City of Huntington Beach Planning Department

STAFF REPORT

SUBJECT: **MITIGATED NEGATIVE DECLARATION NO. 08-011/ COASTAL DEVELOPMENT PERMIT NO. 08-005/ CONDITIONAL USE PERMIT NO. 08-011 WITH SPECIAL PERMIT NO. 08-002/ VARIANCE NO. 08-006 (Pacific View Mixed Use Building)**

LOCATION: 620 Pacific Coast Highway, 92648 (Northeast corner of Pacific Coast Highway and Seventh St.)

- Study of setbacks between Seventh St. and Main St.

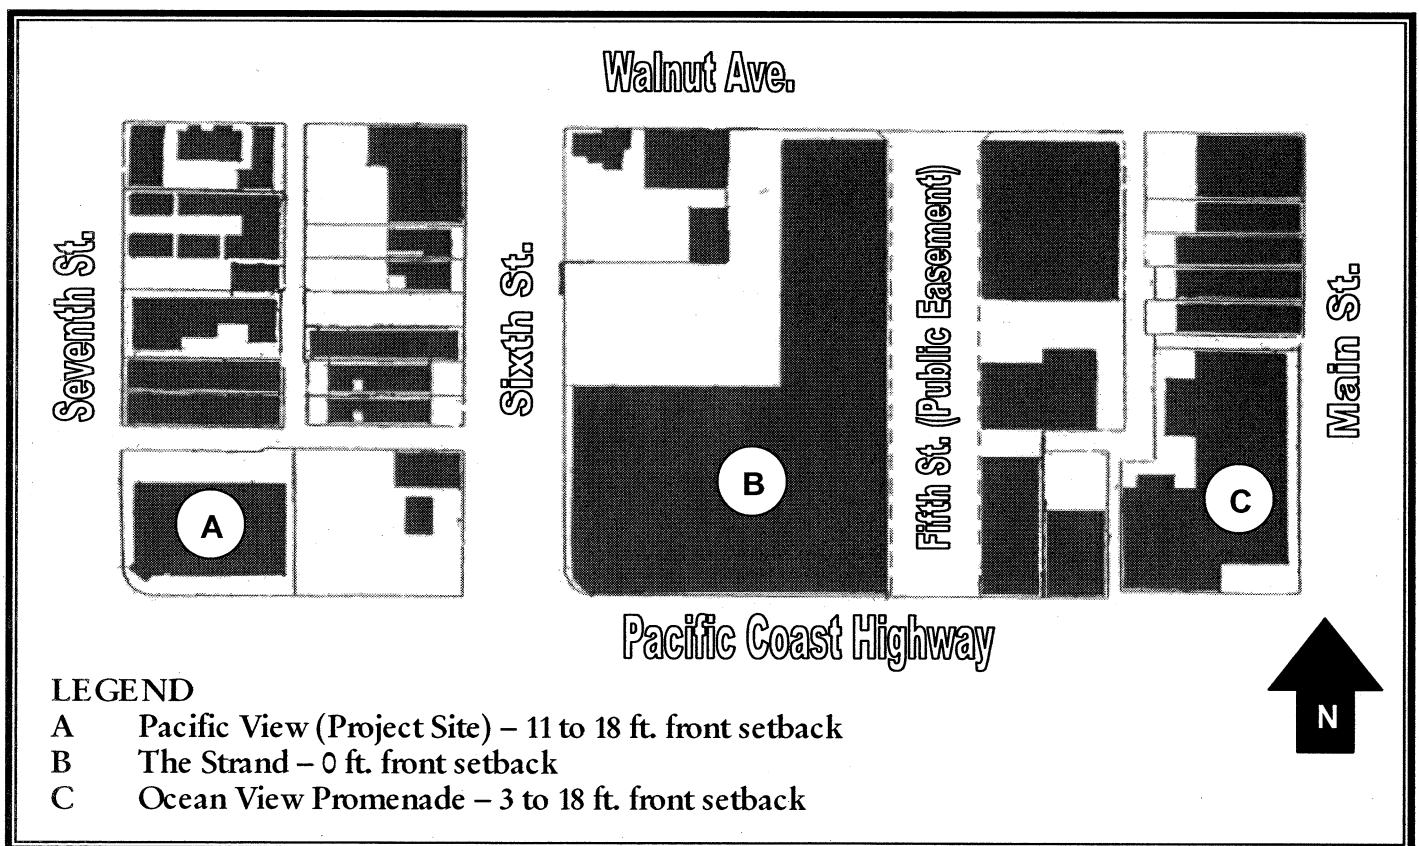
The Planning Commission requested a study of the setbacks for proposed project in comparison with the adjacent surrounding structures. The graphic below depicts the setbacks for the proposed development in comparison with the structures along PCH from Main St. to 7th St..

ROOF DECK
SCALE 1/8" = 1'-0"

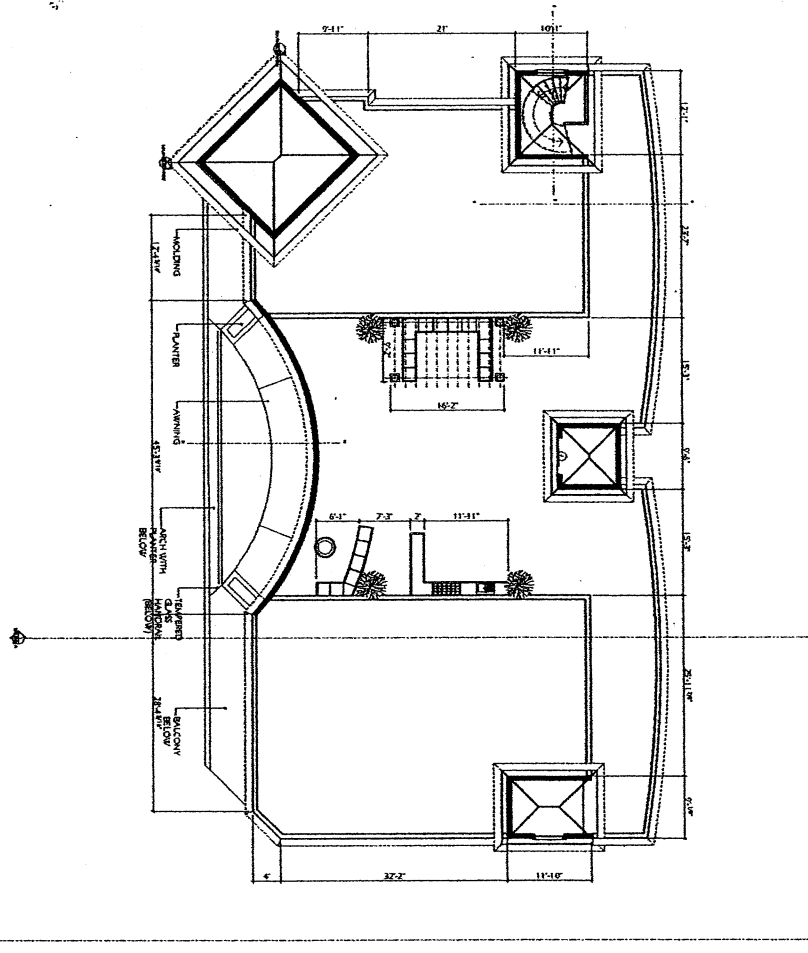
The General Plan limits the number of stories within Community Subarea 1C to three stories. The project proposal includes a request for a variance to allow a fourth floor in lieu of the maximum allowed three floors. The fourth floor is designed as an uncovered deck to provide required common open space for the residential units. The design of the fourth floor is incompatible with the adjacent residential uses to the north. Because the fourth floor deck encompasses the majority of the top level of the structure at the rear elevation, the provision of a fourth floor is not consistent with the maximum allowed number of floors identified in the General Plan and that the edge of the building is massive and bulky adjacent to the maximum three story residential uses to the north.

The applicant contends that given the lot size, nature of mixed use development, parking requirements, and amount of open space required by the code (2,229 sq. ft.), the site is limited in terms of viable locations for accommodating the open space requirement. The solution presented by the applicant is to provide a fourth floor deck in lieu of the maximum three floors for purposes of providing common open space.

A review of the submitted plans also indicates that other opportunity exists for providing common open for the development. While the proposal complies with the maximum allowed density and maximum allowed floor area ratio, the number of residential units could be reduced and adequate common open space could be provided on the third floor, eliminate the need of a fourth floor deck. Granted, this alternative design may reduce the economic feasibility of the project; however the costs and economic feasibility associated with building in compliance with the applicable codes (absent unique circumstances associated with the property) are not, under the provisions of the HBZSO, a basis for the granting of a variance.

ALLEY DEDICATION PLAN
 SCALE: 1/8" = 1'-0"

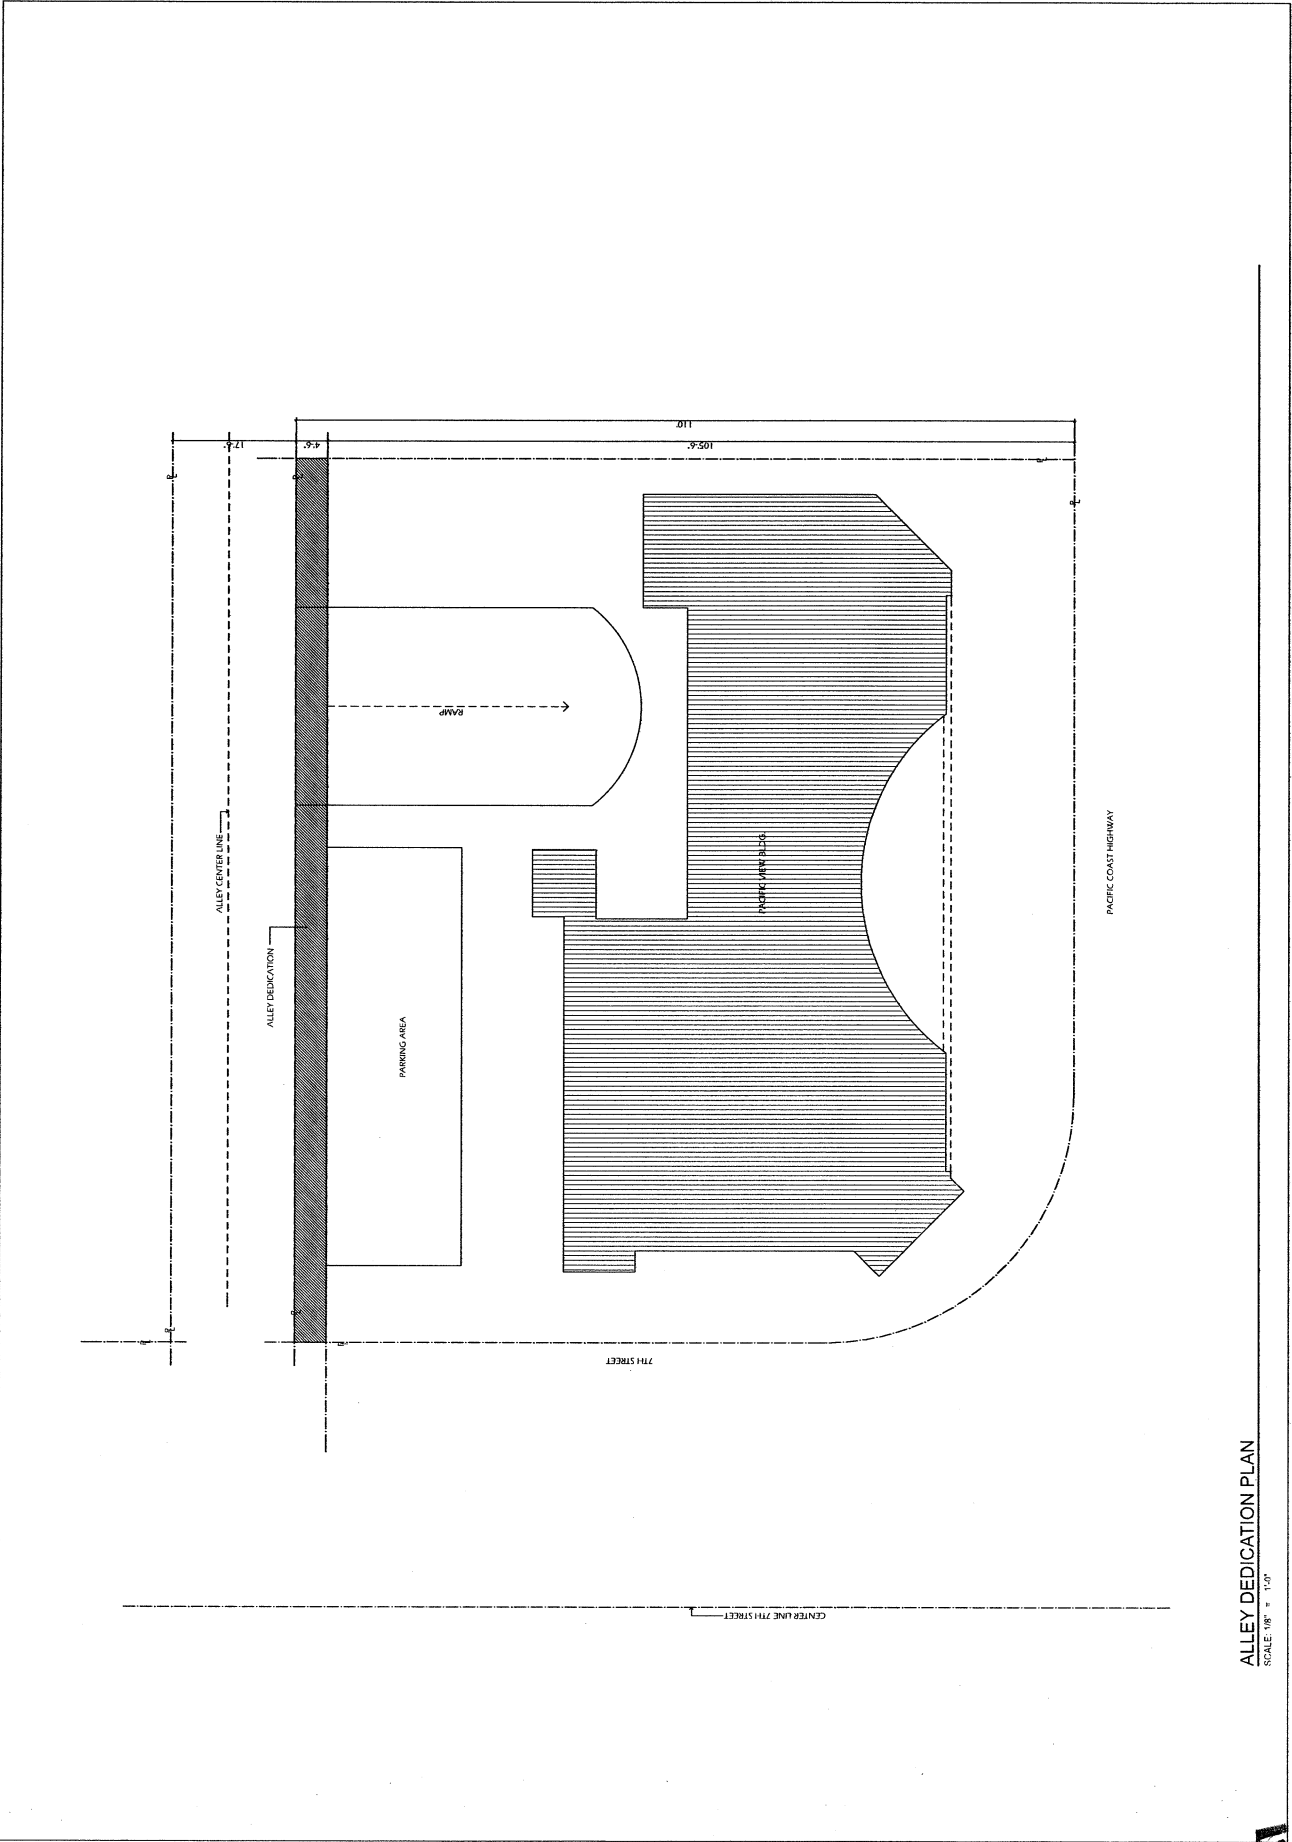
The Planning Commission requested a plan showing the full width of the alley. The applicant has prepared a plan provided in Attachment No. 5 which depicts the full width of the alley.

1. The following dedication to the City of Huntington Beach shall be shown on the Grading Plan (ZSO 230.084A).
 - a. 4.5-feet of additional alley dedication. This will bring the alley right-of-way line to 12-feet from alley centerline. (ZSO 230.84)

ATTACHMENT NO. 6.3

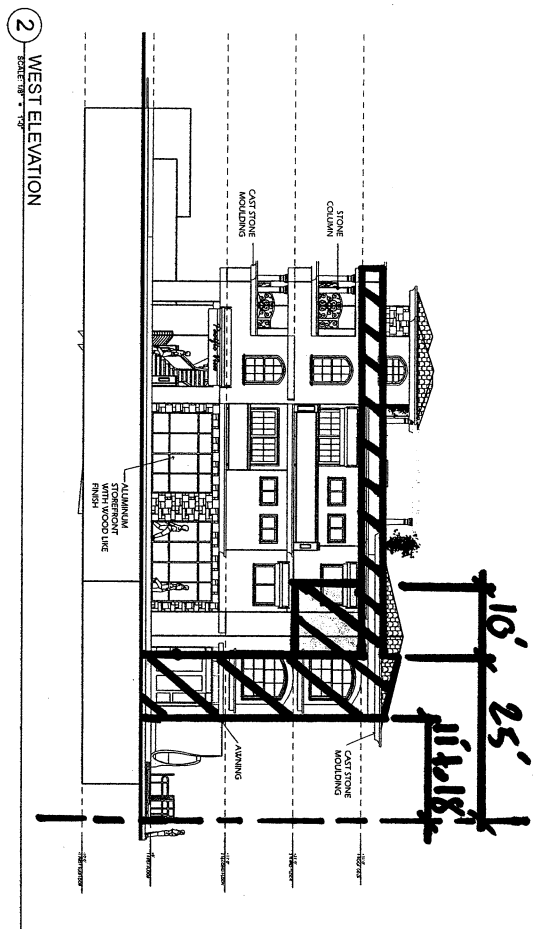
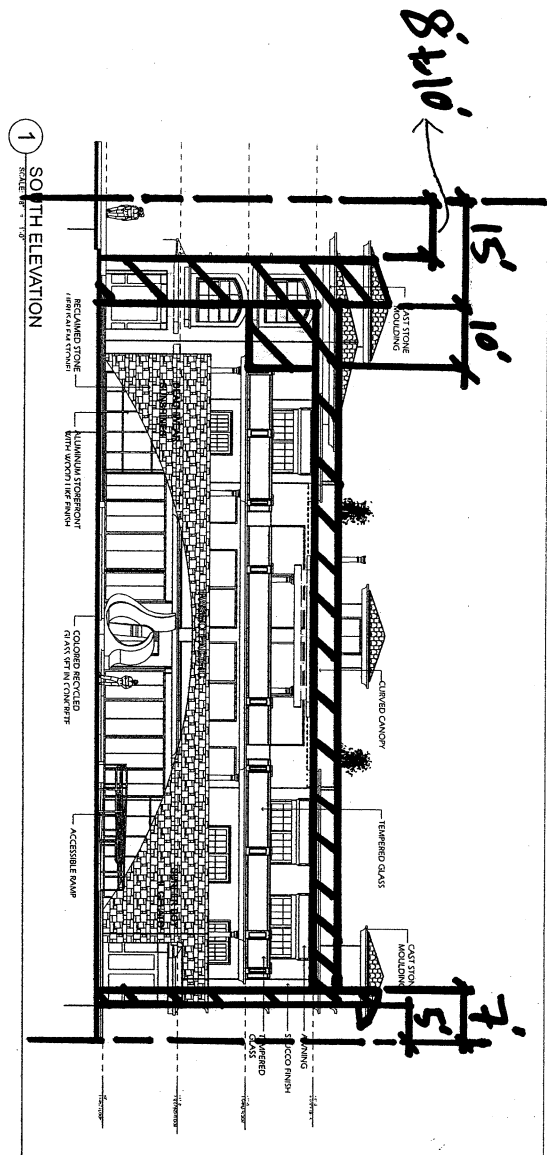
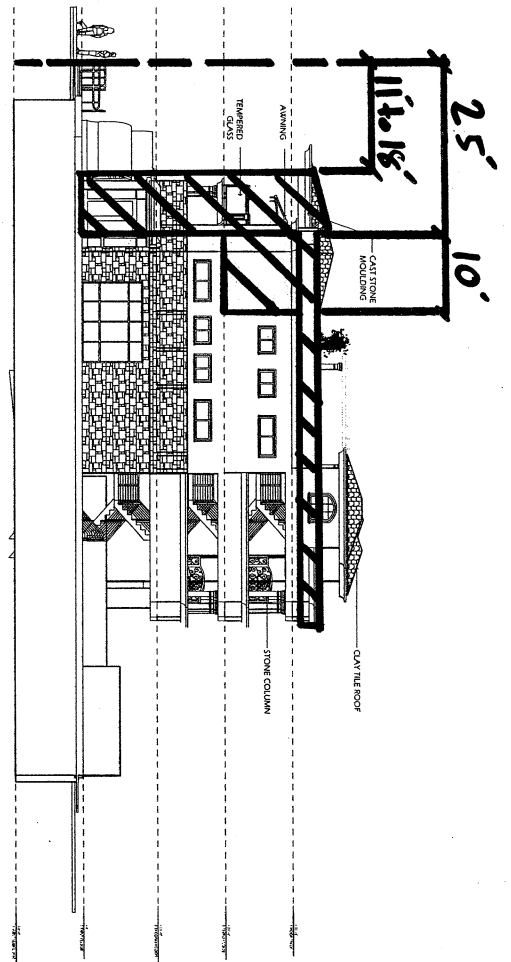
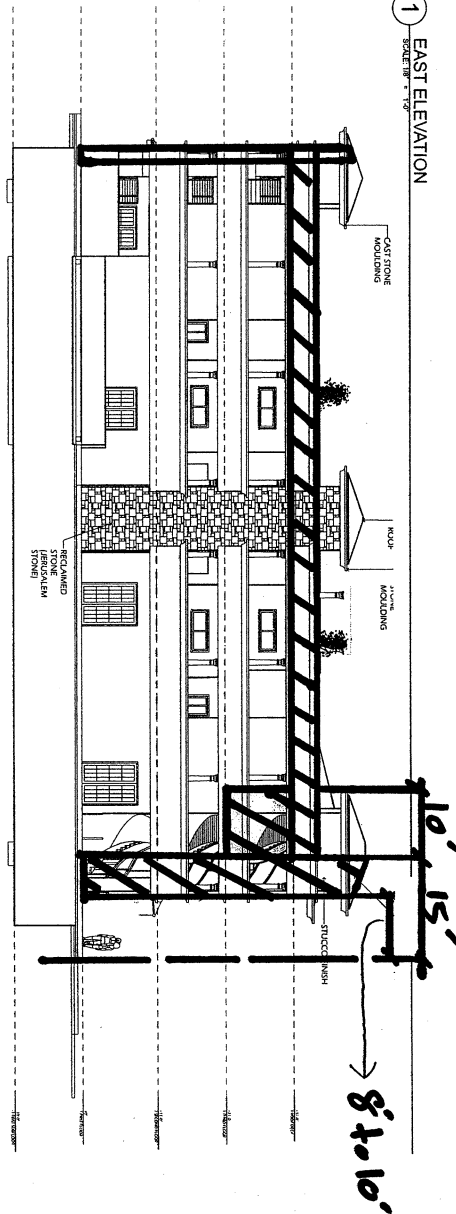
- To permit a reduction of the minimum upper story setbacks along Pacific Coast Highway (6 ft. in lieu of min. average of 10 ft.).
- To permit a reduction of the minimum upper story setbacks along Seventh Street (0 ft. in lieu of min. average of 10 ft.).
- To permit an increase of the maximum allowed slope for parking garage transition ramps (15% in lieu of the max. 10%).

The applicant is requesting approval of six special permits (For a depiction of the special permit request see Attachment No. 6). Section 4.1.02 of the Downtown Specific Plan allows the Planning Commission to grant special permits for deviations from the development standards of the Downtown Specific Plan. Special permits may be approved when the Planning Commission determines that significantly greater benefits from the project can be provided than would occur if all the minimum requirements were met.
